09 - 2011
BDF454 / BDF454Z / BDF454F
18V 1/2" CORDLESS DRIVER DRILL

SERVICE CHANGES

1. Changes on Switch, Terminal, and Housing Set (Battery Protection Circuit)

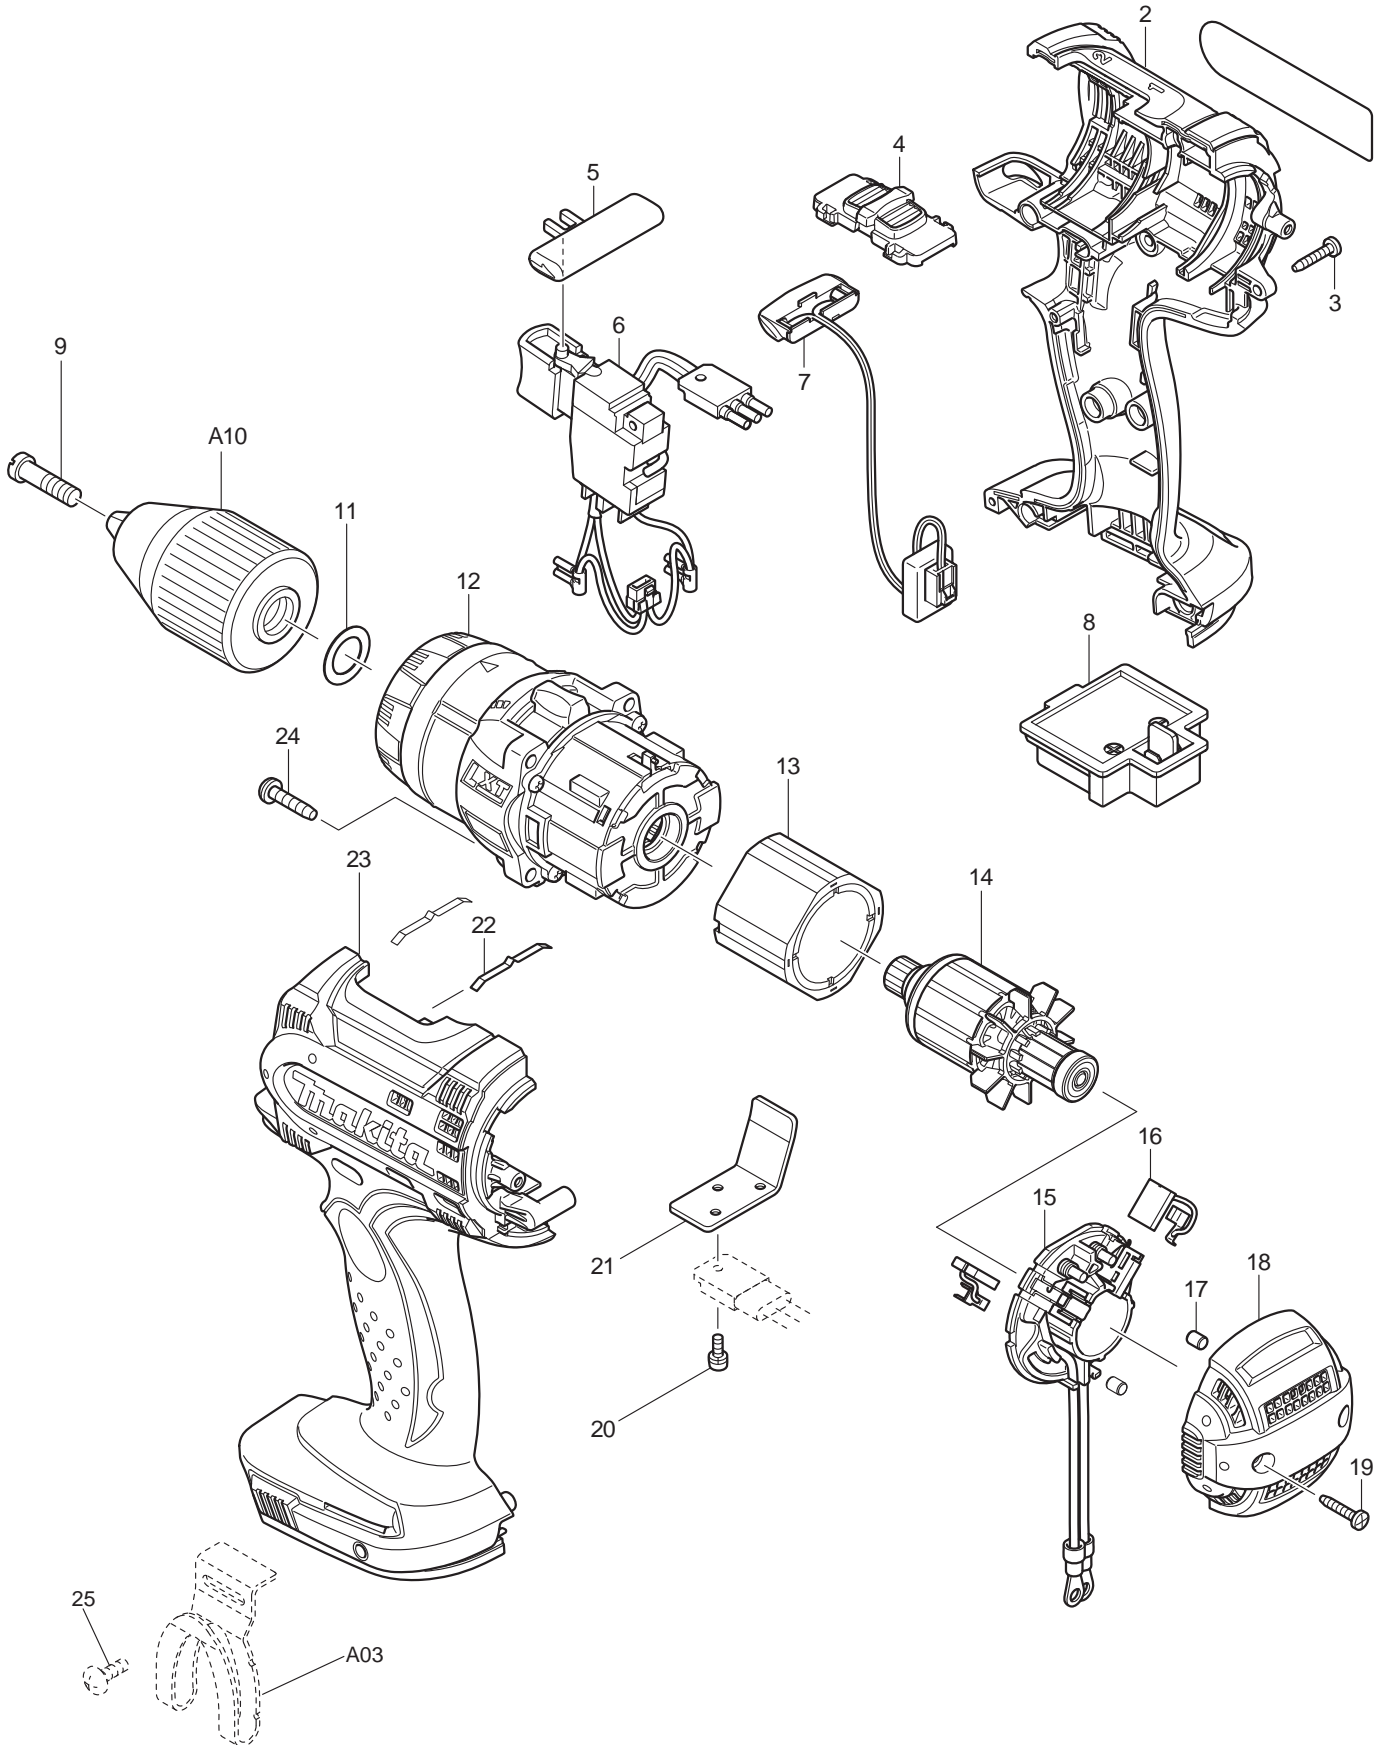
Item No.	Description	Type 1	Type 2	Type 3
2	HOUSING SET		188525-5	187356-9
6	SWITCH		650573-9	650693-9
8	TERMINAL	643812-4	643838-6	643859-8

Above parts are completely interchangeable as a set.

- Use new parts for repair of the model manufactured on or after March 2012 with using Yellow lead wire between Switch and Terminal.
- Use current parts for repair of the model manufactured before March 2012 without using Yellow lead wire between Switch and Terminal.

*** See Technical Information No. 94114 for Wiring changes.**
